ANN ARBOR HISTORIC DISTRICT COMMISSION

Staff Report

ADDRESS: 200 East Washington Street, Application Number HDC14-027

DISTRICT: Main Street Historic District

Elevations

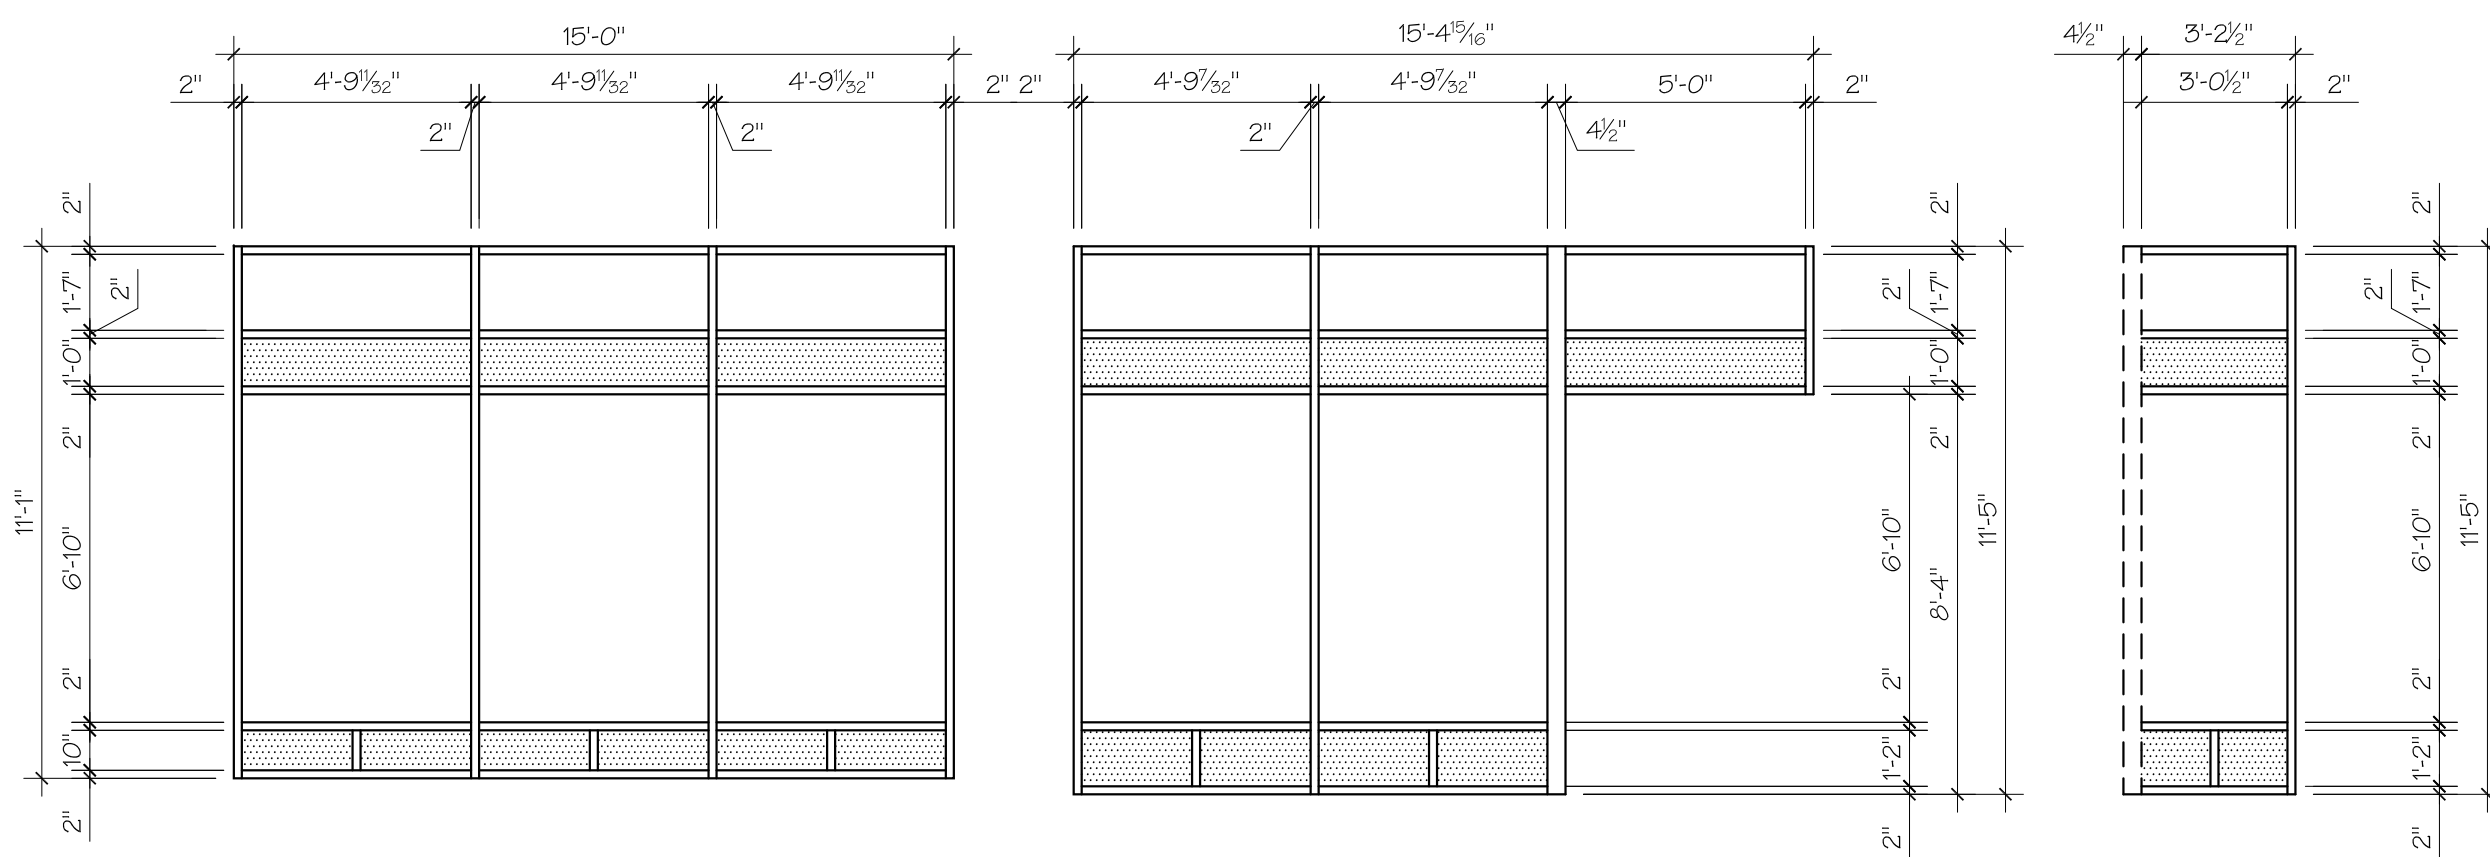
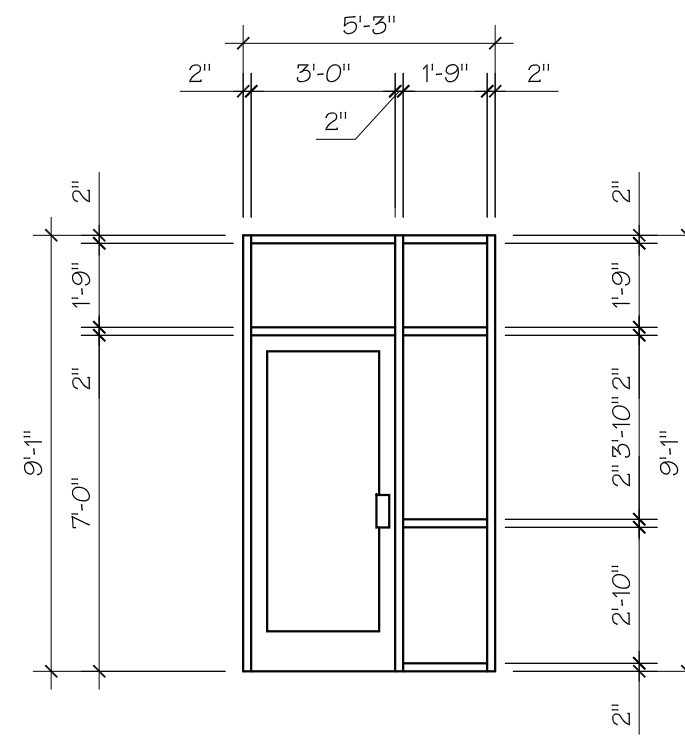
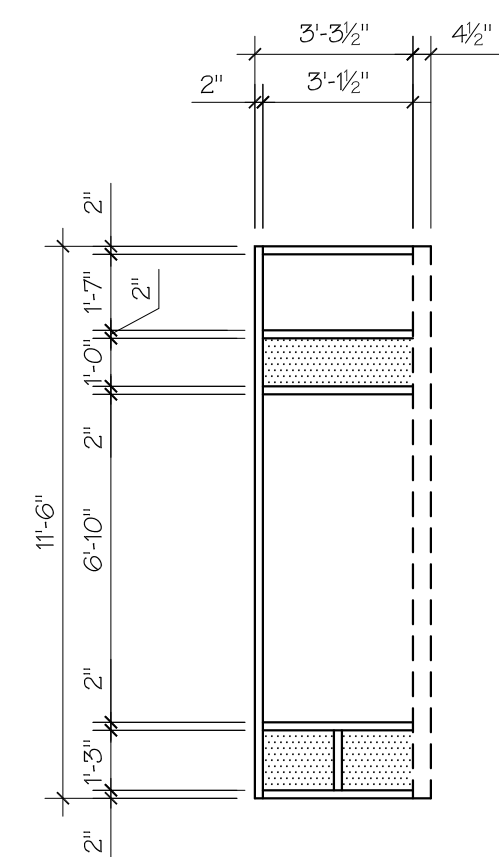
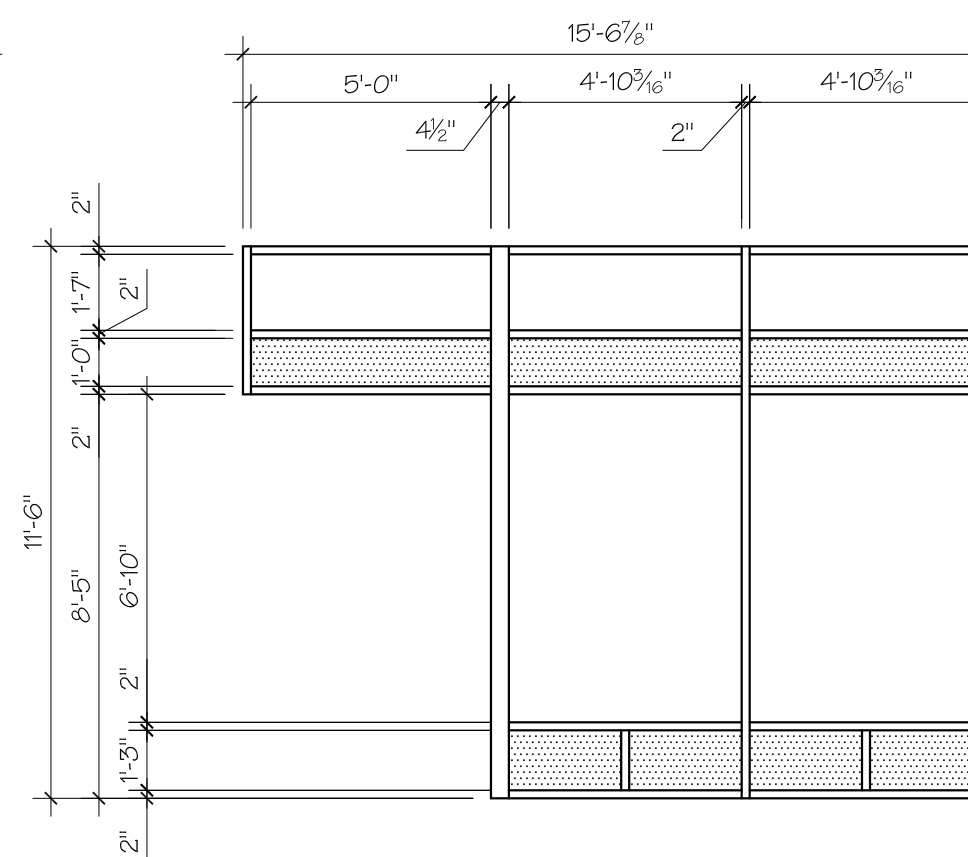
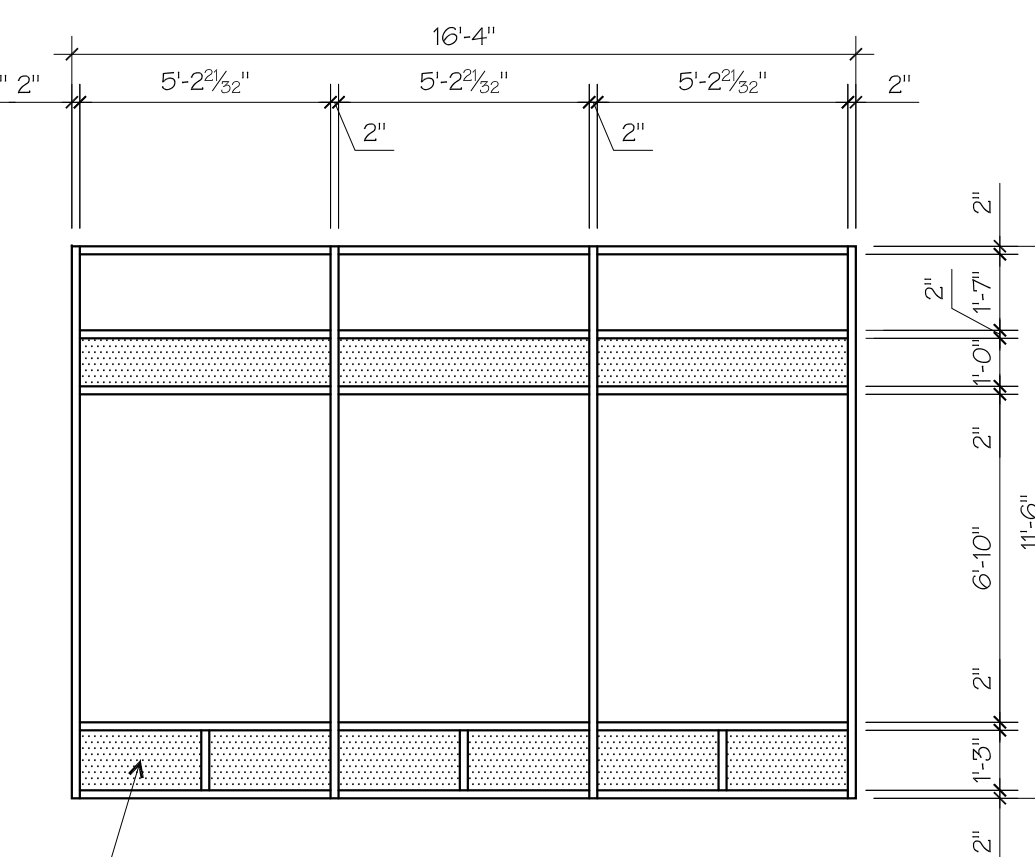
5. The application proposes to install a new aluminum window system with 2" frames. The two larger windows would be divided into three panes, and the inner windows (next to the corner door) would be divided into two panes. Each window's transoms would be divided into three parts instead of two. The wood beams and awning gutters that currently divide the transoms from the display windows are proposed to be removed. A metal panel of the same width is proposed to simulate the beam. The wood kickplate is proposed to be removed and the drawings submitted show aluminum infill. The building manager has proposed to replicate the kickplate in Azek and apply it to the new aluminum frame, though drawings have not been provided.

6. The division of the windows into three panes, as shown on the drawings, is not appropriate. Each storefront bay is flanked by heavy stone columns which continue up the side of the building as even heavier brick columns. The middle of each bay, and every transom, aligns with a more slender brick column above. This vertical element needs to be retained in the new windows. That means either a single sheet of glass or a sheet with one centered division is appropriate for the two larger display windows, and a single pane for the smaller ones closer to the door. The transoms should remain in two equal sections.

7. The use of a 2" aluminum window system instead of the current steel is appropriate if the divisions above are applied. The use of insulated glass instead of a single sheet of plate glass is appropriate. The use of an aluminum panel to cover the header beam may be appropriate, but a sample must be reviewed by the commission to ensure that it replicates the appearance of the original.

8. The complete loss of the wood kickplate and its detailing is not appropriate. The kickplate is important in defining the overall historic character of the building. Replicating it in Azek or a similar material might be appropriate, since hardwood installed today won't last nearly as long as this wood from 90 years ago. A sample window panel constructed of the material will be necessary for the HDC to review. Matching the detailing of the kickplate includes matching not only the dimensions, but the number of panels currently below each storefront. While staff would prefer to see glass restored in each panel, it may be acceptable to use a solid panel, but this must be reviewed by the HDC.

- a. The transoms must be two panes of glass of equal size.
- b. The two larger, outer display windows must be two equally sized panes of glass, or one single pane.
- c. The two inner display windows closest to the door must be a single pane of glass.
- d. The entire kickplate must be restored, or if the wood is deteriorated beyond repair, its appearance from the exterior of the building must be replicated.
- e. All glazing and framing must match the inset of the current glazing and framing on the exterior of the building.

- a. The transoms must be two panes of glass of equal size.
- b. The east display window on East Washington and the south display window on South Fourth must be two equally sized panes of glass, or one single pane.
- c. The west display window on East Washington and the north display window on South Fourth must be a single pane of glass.
- d. The entire kickplate must be restored, or if the wood is deteriorated beyond repair, its appearance from the exterior of the building must be replicated.
- e. All glazing and framing must match the inset of the current glazing and framing on the exterior of the building.
